PC#12

I am commenting on PBC \$2007-146 (Fox Moraine Landfill Appeal). I am a Kendall County resident who lives at 14574 Budd Road, Yorkville, IL 60560. I am assigned a Yorkville address and my home, for the past twenty-five years, is located 1.5 miles (as a crow flies) west-northwest of the proposed Fox Moraine landfill location. I attended a majority of the landfill siting hearings so I understand the facts and the Pollution Control Board's process for siting a landfill in Illinois.

RE: PCB CASE #2007-146 (Fox Moraine LLC v. United City of Yorkville)

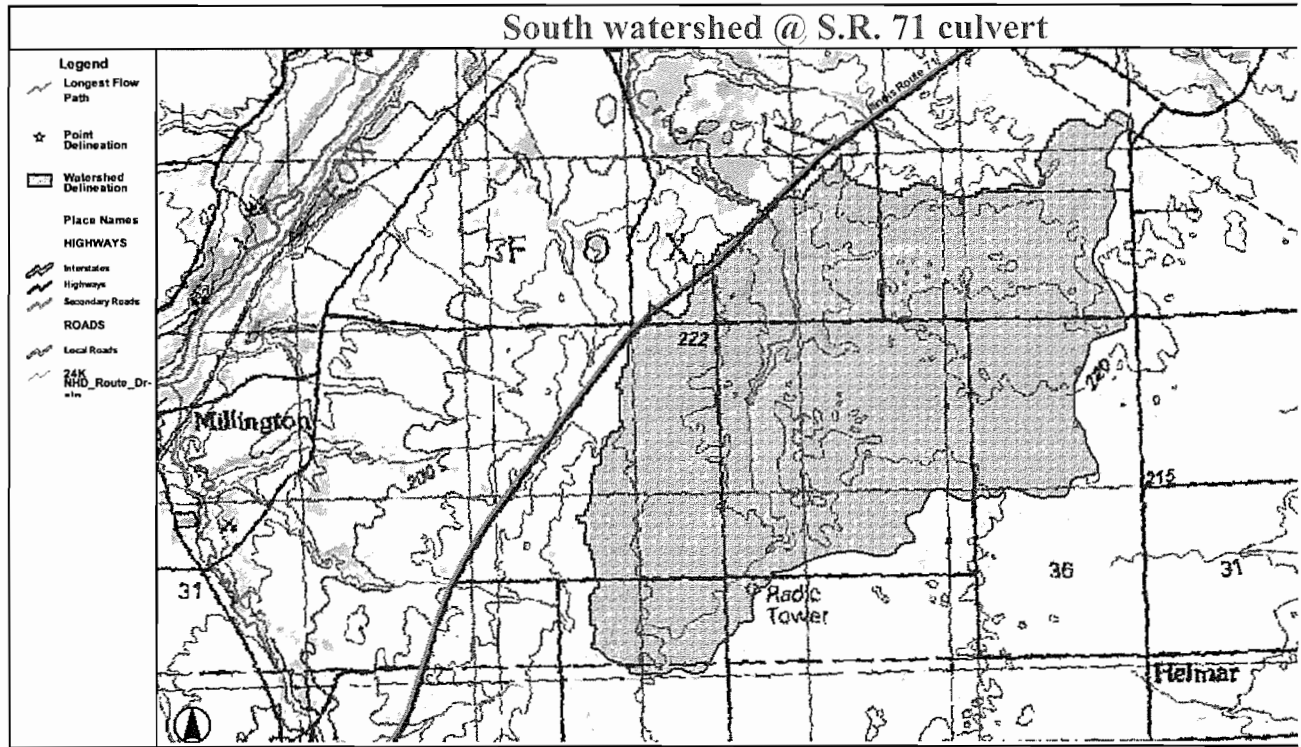
$$Q_{100} = 324 \text{ cfs} / 0.96 \text{ mi}^2$$

North Watershed @ S.R. 71 culvert

South WATERSHED

$$Q_{100} = 1080 \text{ cfs} / 6.2 \text{ mi}^2$$

Combined Hollenbeck Creek Watershed @ Budd Road box culvert

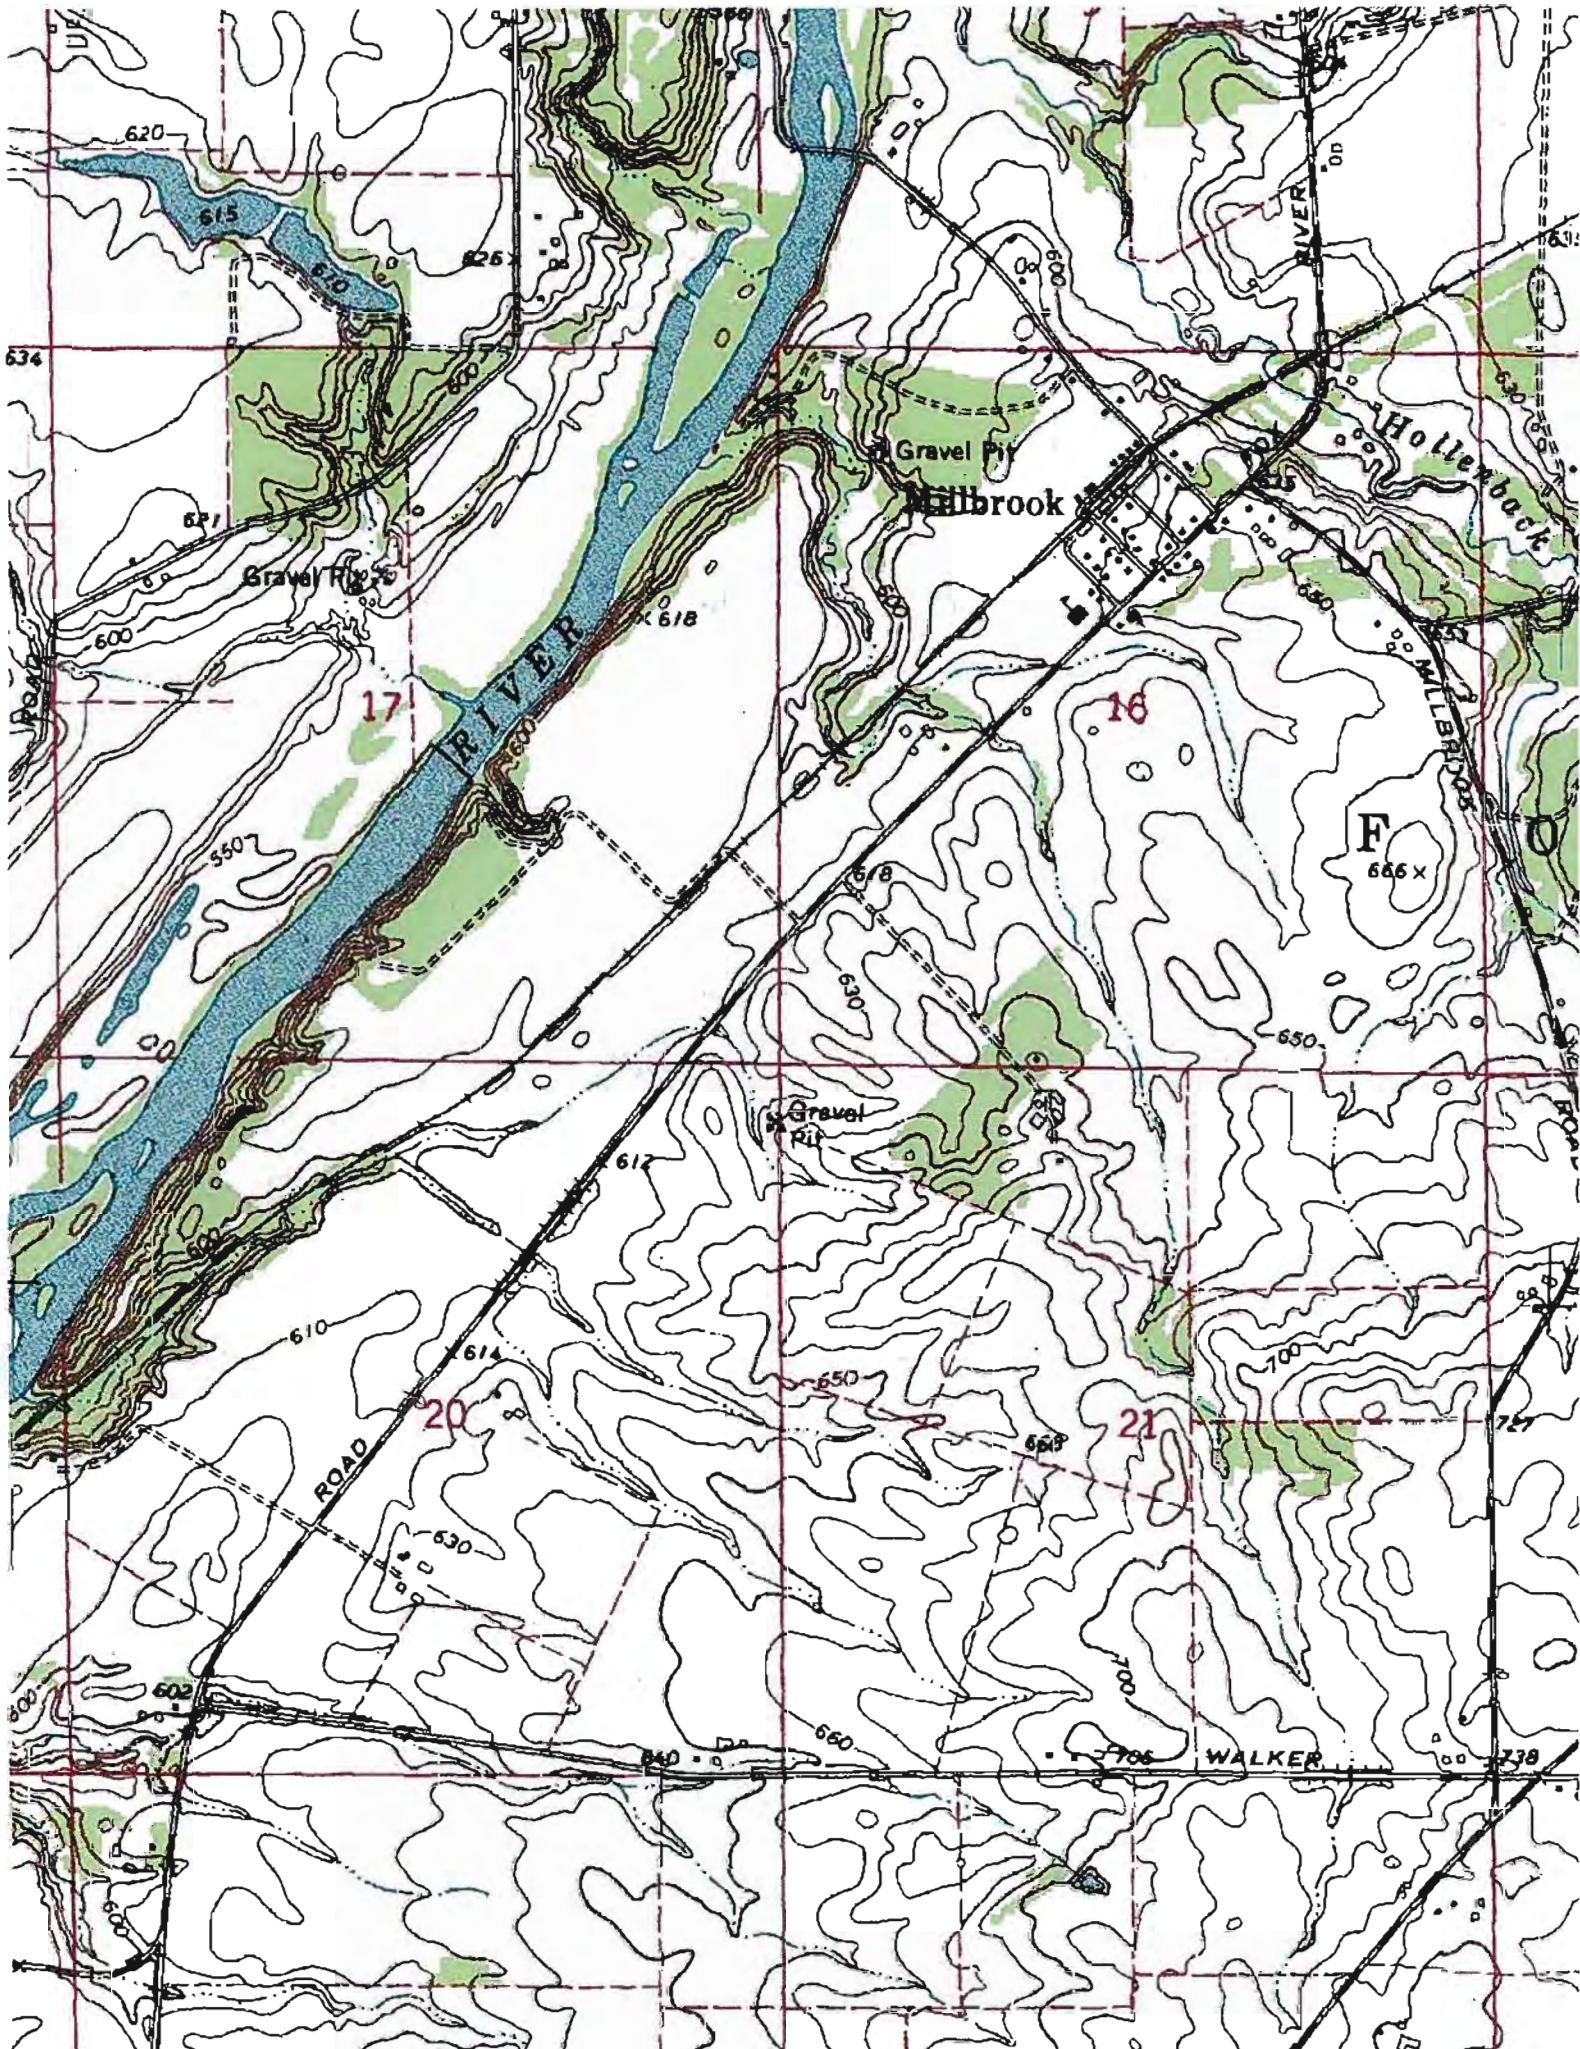
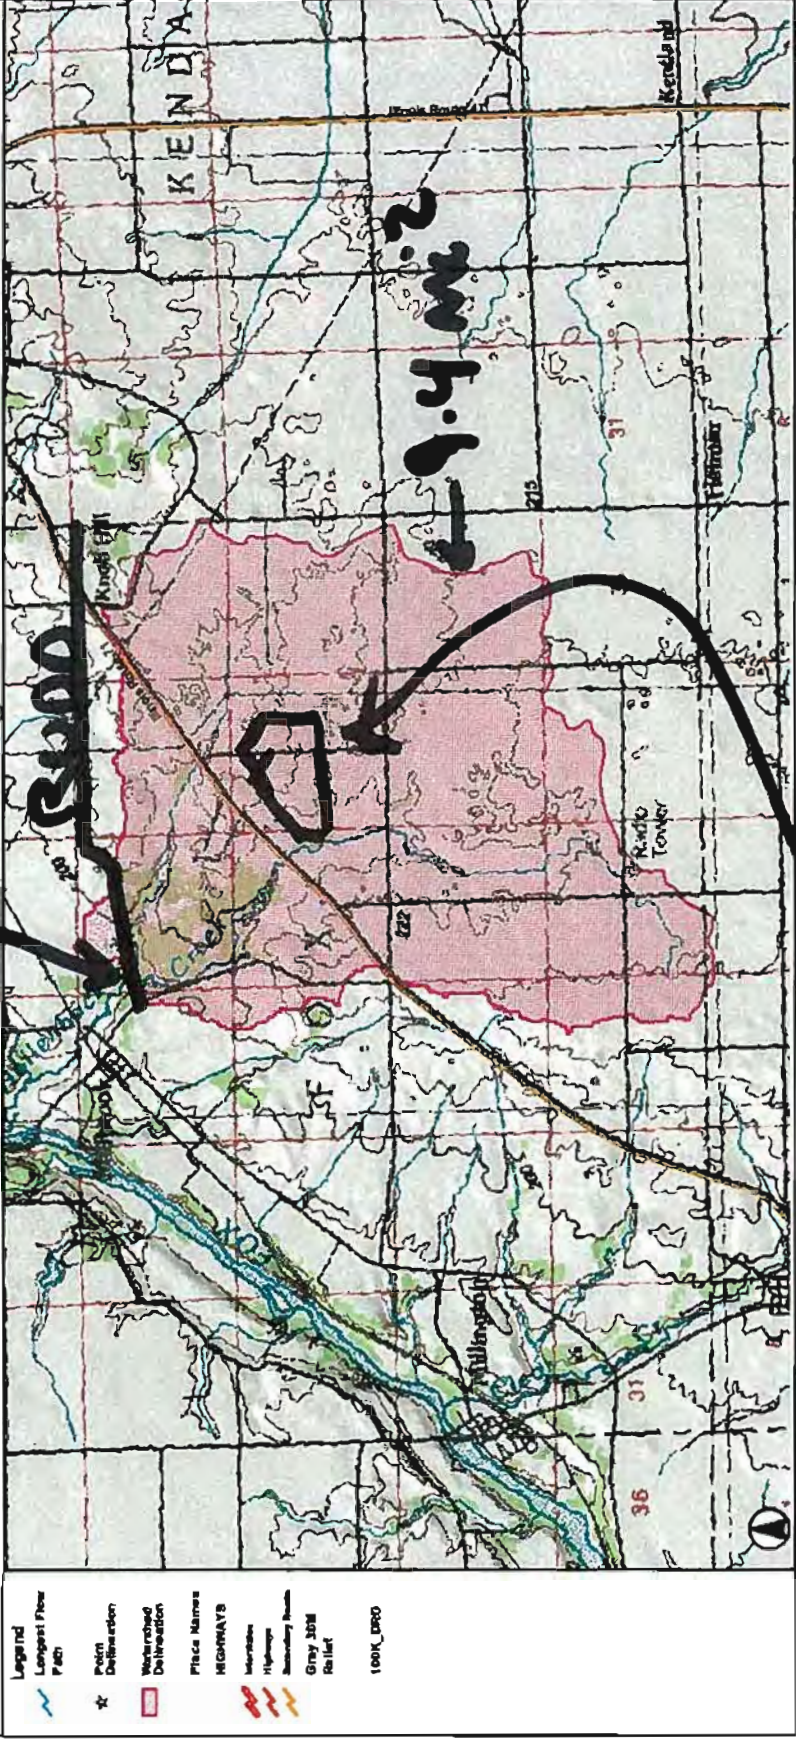
Box culvert @ Budd  
Q<sub>100</sub> = 1430 cfs

LANDFILL DIRECTLY CENTERED IN UNSTUDIED WATERSHED WITH PRISTINE RESOURCES
